SUTHERLAND SHIRE COUNCIL ASSESSMENT REPORT

Panel Reference	PPSSSH-104
DA Number	DA21/1131
LGA	Sutherland Shire
Proposed Development	Demolition of existing structures, construction of a light industrial complex containing 116 units with ancillary office space and associated vehicular access, parking and outdoor recreation space.
Street Address	72-78 Box Road, Taren Point, NSW 2229
Applicant/Owner	Mount Street 1 Pty Ltd As Trustee For Mount Street 1 Unit Trust
Date of DA lodgement	11/11/2021
Number of Submissions	13
Recommendation	Refusal
Regional Development Criteria (Schedule 7 of the SEPP (State and Regional Development) 2011)	This application is referred to the Sydney South Planning Panel (SSPP), as the development meets the criteria under Schedule 7, 2 of the NSW <i>State Environmental Planning Policy (State and Regional Development) 2011</i> . The development has a capital investment value (CIV) of more than \$30 million.
List of all relevant s4.15(1)(a) matters	<ul style="list-style-type: none"> • <i>State Environmental Planning Policy (Biodiversity and Conservation) 2021 Chapter 11 Georges River Catchment.</i> • <i>State Environmental Planning Policy (Planning Systems) 2021

Figure 10.1 Excerpt of daylight analysis showing ground floor of the proposal (Source: Rothelowman)

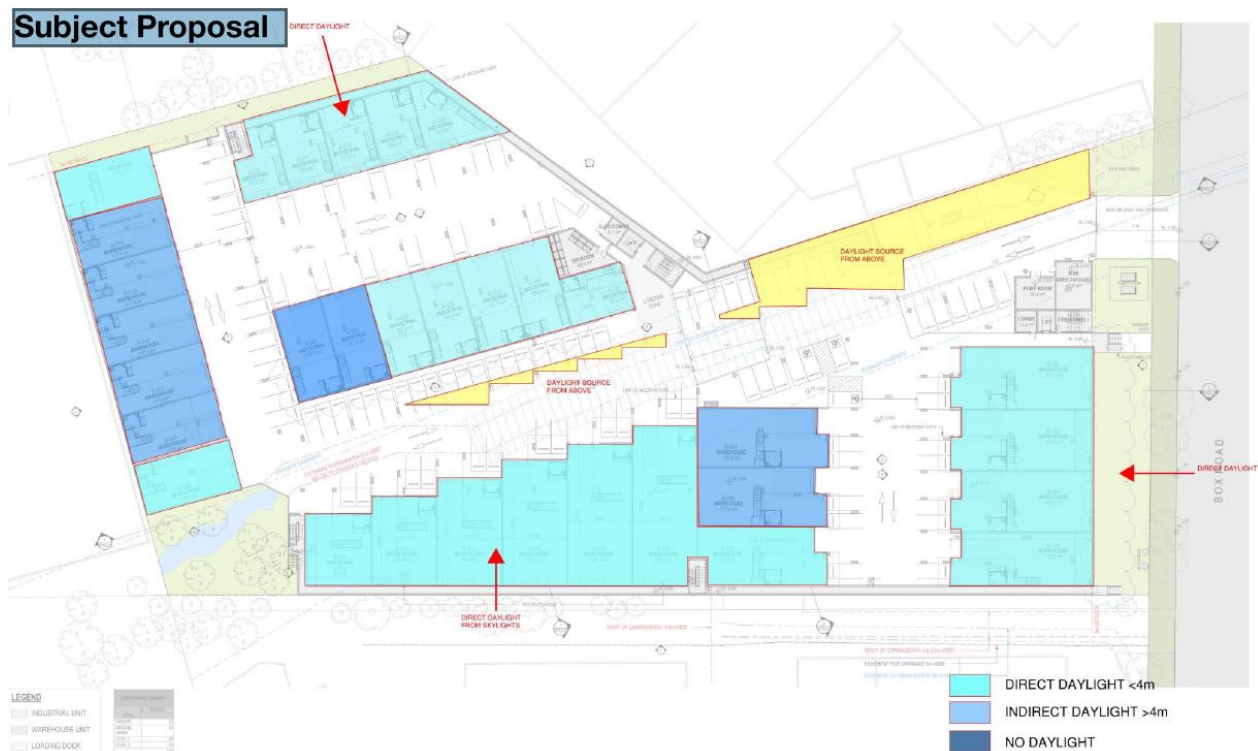
Many of the units and associated office spaces are internalised and receive no daylight, access to direct natural ventilation, or have any desirable outlook to provide reasonable amenity for future occupants. Internalised spaces will be dark and reliant on artificial lighting and mechanical ventilation rather than passive means. This is contrary to the following objectives and controls in Chapter 28 of Council's DCP 2015 (refer compliance table in Appendix A):

This is considered to be an unacceptable outcome and contrary to the relevant objectives and controls of DCP 2015 identified above. It will provide a poor level of amenity to more than a fifth of all of the proposed units, leaving aside any discussion of the level of solar amenity actually achieved by some of the remaining units which the applicant has indicated have direct daylight. An extract of the analysis of the ground floor plan is provided below in Figure 10.1.

With the small level of windows, including many which open only into the car parking area, natural ventilation of fresh air is considered to be poor for many of the units.
